NP-12-0022
June 18, 2012

Subject: Exelon Nuclear Texas Holdings, LLC
Victoria County Station
Early Site Permit Application
Environmental Report – Response to ER RAI Letters No.6 and No.9
Docket No. 52-042

Exelon is responding to the following questions contained in NRC Request for Additional Information (RAI) letter No.6 (Reference 1):

Exelon is also responding to the following questions contained in NRC RAI letter No.9 (Reference 2):

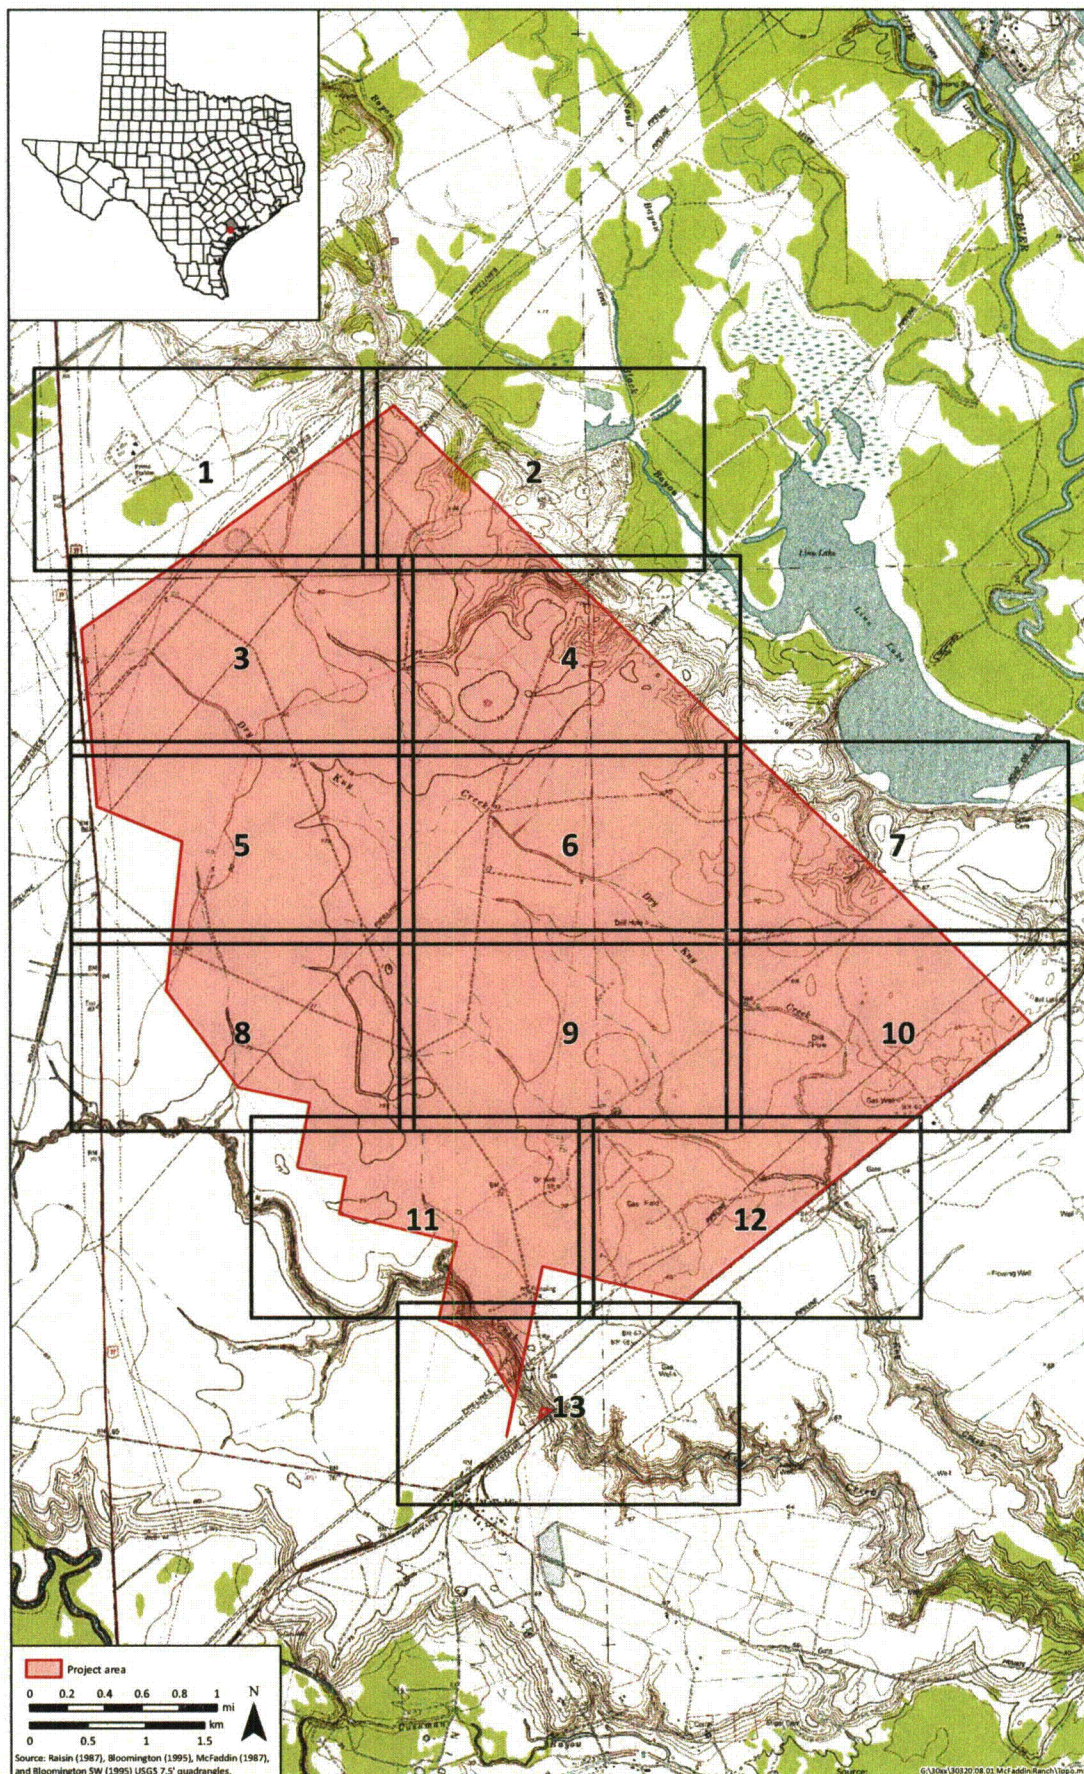
CR-3 ESRP Sections 4.1.3 and 5.1.3 state that the EIS needs to consider all of the effects from the project on historic and cultural resources. Additionally, The National Historic Preservation Act of 1966, as amended (36 CFR 800) requires that Federal agencies consider the effect of undertakings on historic properties. 36 CFR 800.4, "Identification of historic properties," requires that the agency identify what resources could be affected by the undertaking. Resources located on the property could be affected if a nuclear power plant is built. The spatial distribution of these resources may affect the nature of the project's effects. Provide a map showing the location of all significant resources including the contributing properties to the McFaddin Ranch Rural Historic Landscape which was designated by the Texas Historical Commission (THC) on the VCS property.

The Texas Historic Commission concurred that the eight archaeological resources (5 sites and 3 localities) identified on the property are not eligible for listing on the National Register of Historic Places. Thus, the only significant resources (i.e., historic properties) on the property are the contributing resources to the McFaddin Ranch Rural Historic Landscape. The attached includes a table of the contributing resources keyed to 13 maps (also attached) of the McFaddin Ranch Rural Historic Landscape.
